Comments on Improvements to the Y+ Configuration Set

Al Wootten 2008 Aug 19

Figure 1 Naturally weighted beam sidelobe levels from configuration 20 through configuration 29, natural weighting.

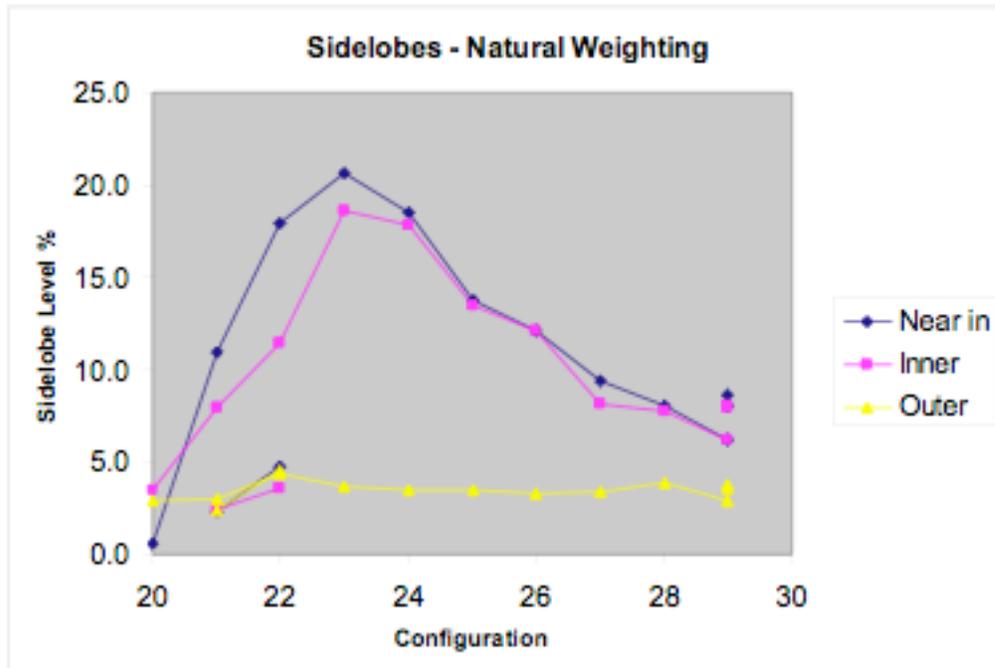
A design for the outer configurations of ALMA, tentatively numbered 21-29, was presented in ALMA-90.02.00.00-008-A-DSN. The design approach was to optimize the most extended configuration, then to fill in the intermediate configurations down to the largest of the inner configurations as specified in ALMA-90.02.00.00-006-A-SPE. This resulted in a jump in sidelobe levels from the outermost of the ALMA-90.02.00.00-006-A-SPE arrays ('Configuration 20') to the innermost of the ALMA-90.02.00.00-008-A-DSN arrays ('Configuration 21'). In a Nov 2007 memo, Hills noted that the sidelobes, found by subtracting a best fitting Gaussian and then dividing the map into three regions – near-in for less than 1.5 beams from the centre, inner for 1.5 to 10 beams and outer for beyond 10 beams, were disturbingly large for intermediate extended configurations. His results are shown in Figure 1.

It was thought that these should be improved, an opinion shared by the ASAC in its 2008 April report to the ALMA Board. In the Response to the ASAC Report on 11 May 2008, Hills responded: ‘The re-examination of the intermediate-resolution configurations has produced a scheme with substantially better sidelobe levels. This does however require the construction of a number of additional pads. The work of quantifying the improvement to the final maps so that we can provide a meaningful estimate of the benefits to set against the benefits of this change is continuing.’ The present document is an effort to define the costs and benefits of the improvement proposed in a draft document ‘**Investigating Improvements to the Y+ Configuration Set**’ by M. Holdaway (see <http://tinyurl.com/5c3jc3>).

Figure 2 Sidelobe levels in the redesigned outer configurations fall below 10%, up to half those found in the configurations proposed in ALMA-90.02.00.00-008-A-DSN.

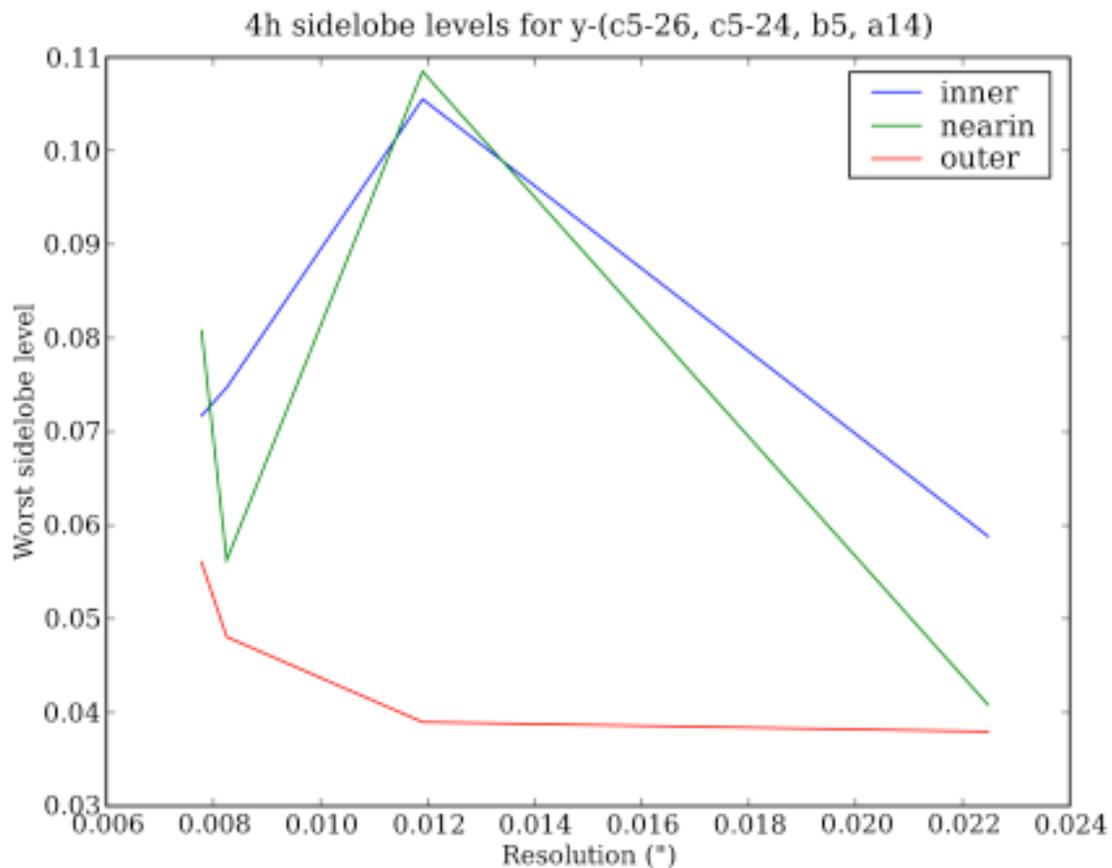
In imaging tests with these arrays, the sidelobe levels shown in Fig 1 are brought beneath 10% in all configurations, at all distances from the center of the primary beam. The resolution of the newly defined arrays is comparable to those previously obtained, as is beam circularity.

Figure 3 uv error amplitudes after cleaning a simulated noiseless 4 hour observation of an M31 H II region using the largest ALMA arrays. **Left: previous array configuration 26; R: optimized array with similar configuration. Note the decreased error amplitudes in the redesigned configuration.**

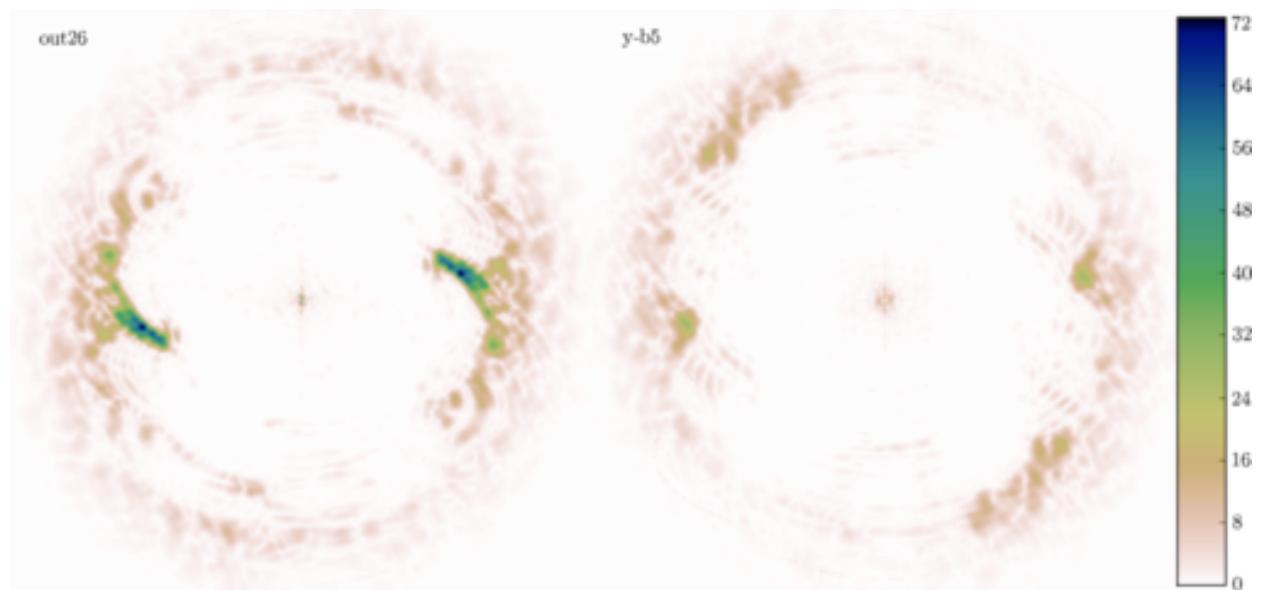
Imaging quality is not necessarily directly controlled by sidelobe levels. Two independent imaging studies were done, by Reid and by Knee, using different sets of images. In those studies, the imaging differences between the configurations proposed in ALMA-90.02.00.00-008-A-DSN and the newly proposed configurations were slight. In a 2008 June 1 report, Reid presented the evidence for improved imaging with the new configurations. An example is shown in Figure 3.

Figure 4 Approximate locations of MA-14 and MA11 are shown. It might be possible to construct an extension of the road reaching P401 to these pads.

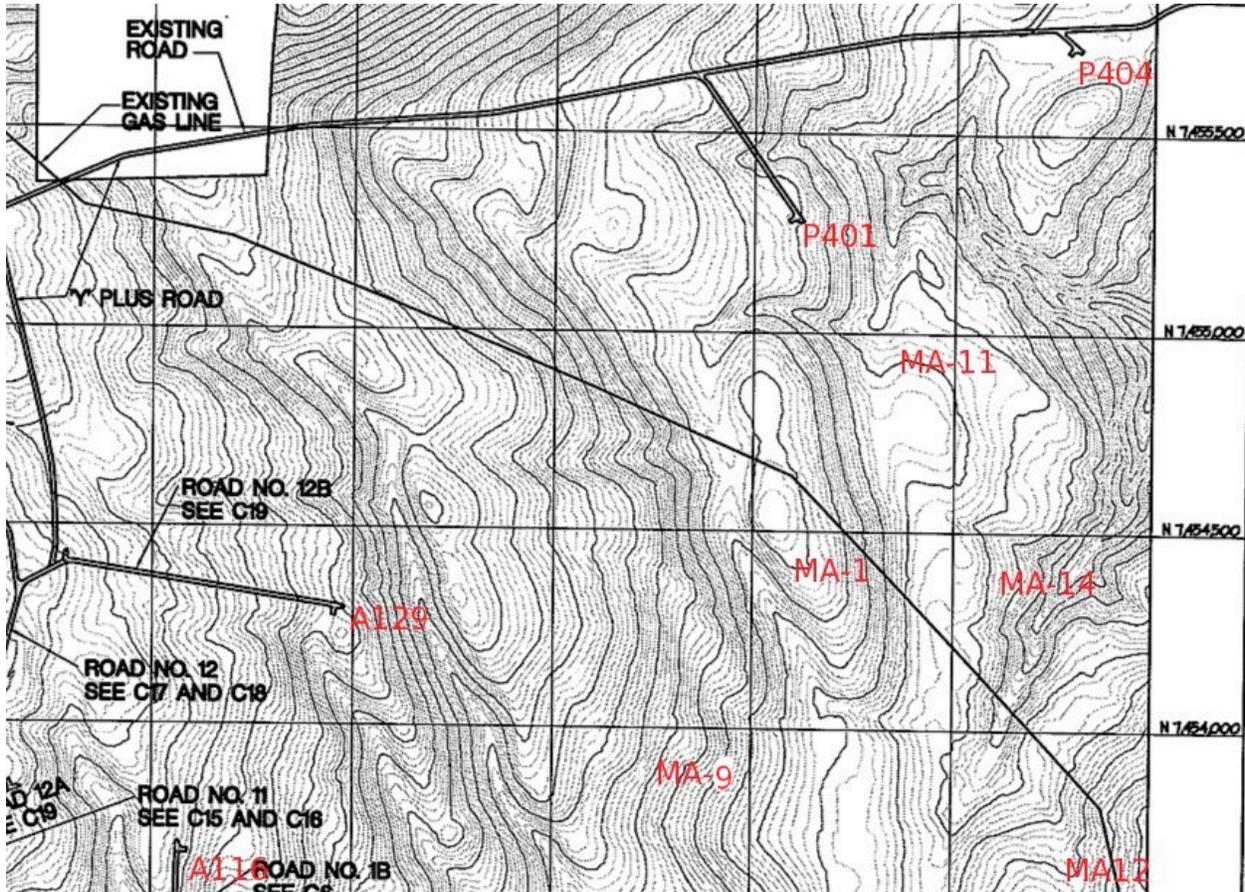
Pad MA-14 lies 1km SE of P401 just across the pipeline crossing. MA-11 lies along the line connecting these two pads. This terrain needs investigation; a new ~1km road could be required to service MA-14 and MA-11.

Figure 5 Four new pads lie between the A121-A129 region and the pipeline in a region where no roads are planned. Approximate locations only are shown. Three locations lie near the pipeline access road.

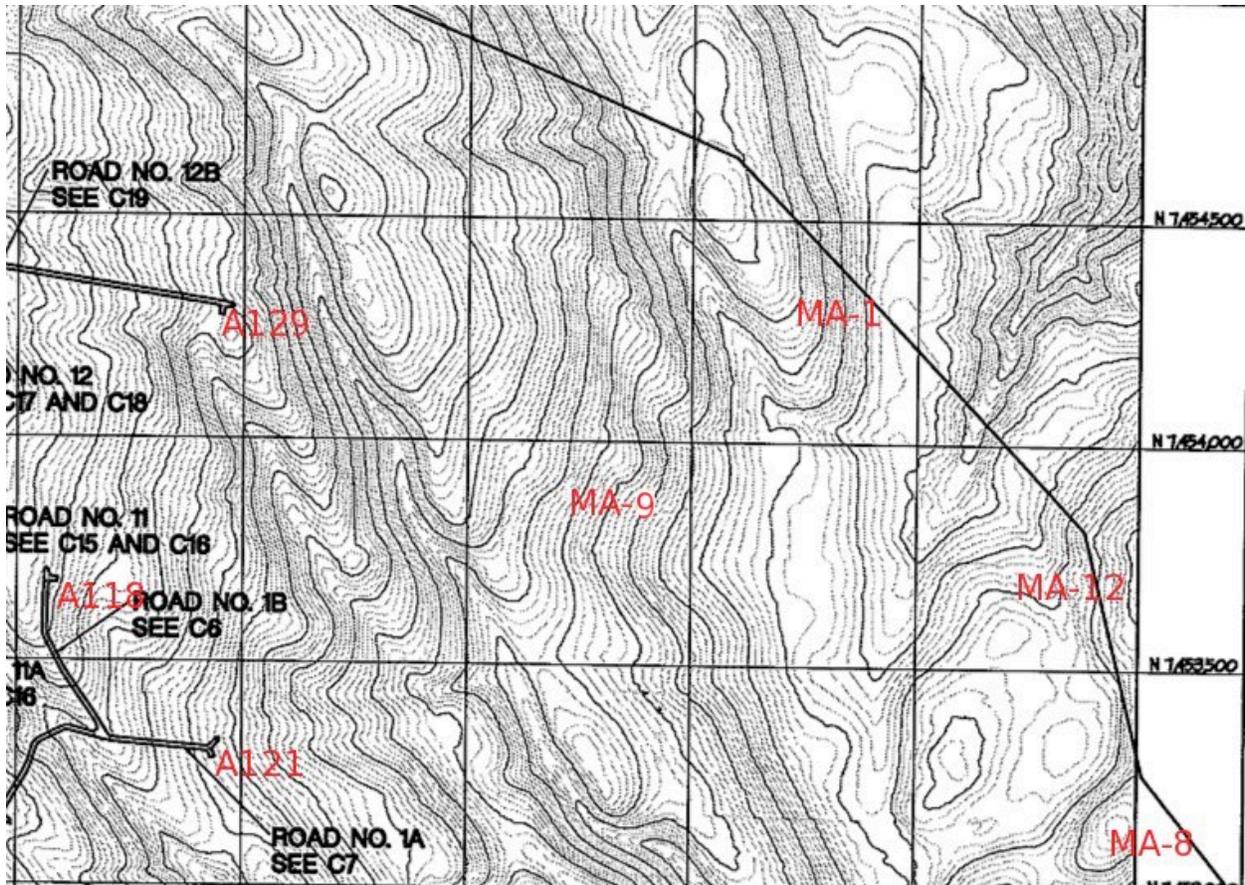
Pad MA-12 lies in a cluster of three new pads SSE of pipeline crossing B. This terrain needs investigation; this region is not reached by a currently planned road. MA-12 lies 1.9 km SE of pad A129 and about the same distance E of A121. See the Figure.

Figure 6 MA-4 in relation to A128 and roads.

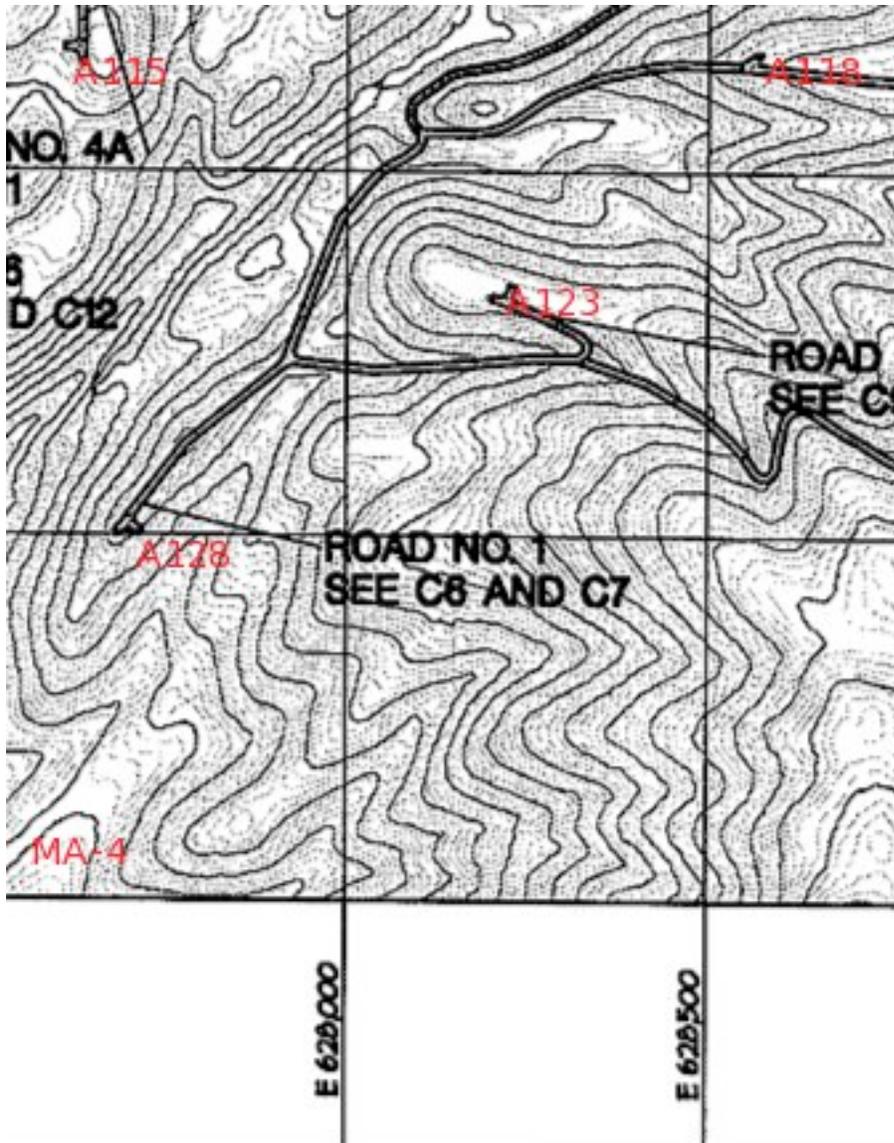
Pad MA-4 lies 0.4 km S of A128. Road 1 might be extended.
